Western Reactive Transfer Interface Definition Change

Christina Catalano
Engineer- Markets Coordination Department
Operating Committee
September 11, 2018

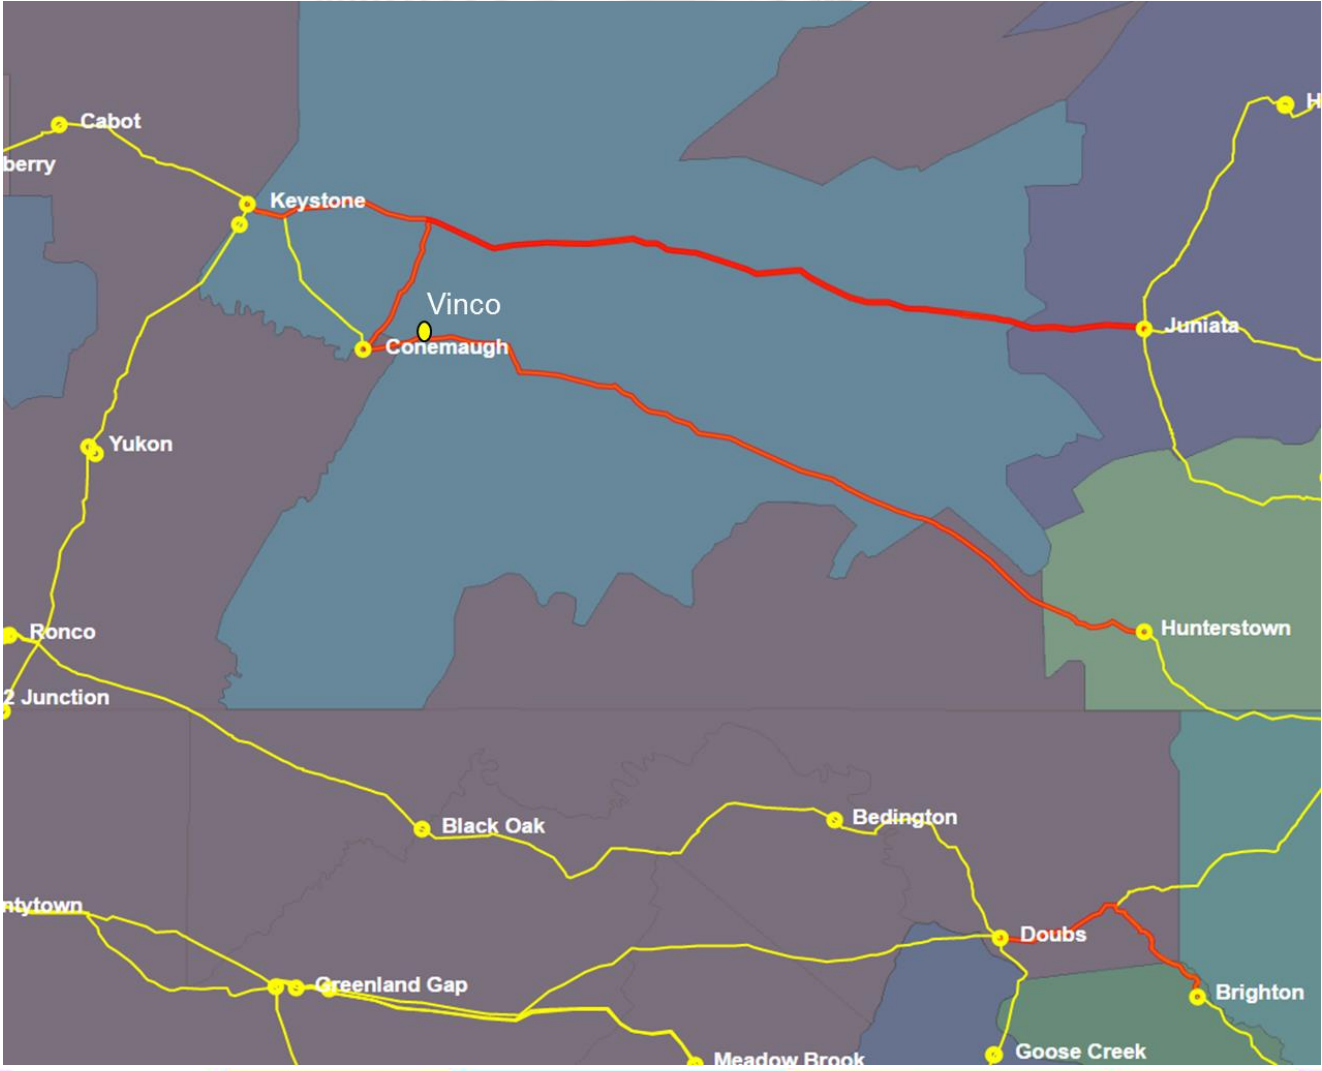
- Definition change is due to Network project n4682.
 - Adds new Vinco substation between Conemaugh and Hunterstown.
 - Definition will be effective when the new substation is energized (est. 10/16/18).

- Current Definition (from-to)
 - 5004 Keystone – Juniata 500 kV line
 - 5005 Conemaugh – Juniata 500 kV line
 - 5006 Conemaugh – Hunterstown 500 kV line
 - 5055 / 522 Doubs – Brighton 500 kV line
- New Definition (from-to)
 - 5004 Keystone – Juniata 500 kV line
 - 5005 Conemaugh – Juniata 500 kV line
 - 5068 Vinco – Hunterstown 500 kV line
 - 5055 / 522 Doubs – Brighton 500 kV line

Interface Definition						
Type	Company	Zone	Station	Voltage	Name	Eq. End
LE	PN	PN	VINCO	500 KV	HUN-VIN	B
LE	PN	PN	CONEMAUG	500 KV	CNM-JUN	A
LE	PN	PN	KEYSTONE	500 KV	JUN-KEY	B
LE	APS	APSS	DOUBS	500 KV	BRI-DOU	B

- Minimal Impact since the new Vinco substation is close to Conemaugh.
- Manual 03: Transmission Operations will be updated with new definition
 - Interface will remain as an IROL in Manual-37.
- Posted Information:
 - <http://www.pjm.com/markets-and-operations/etools/oasis/system-information.aspx>
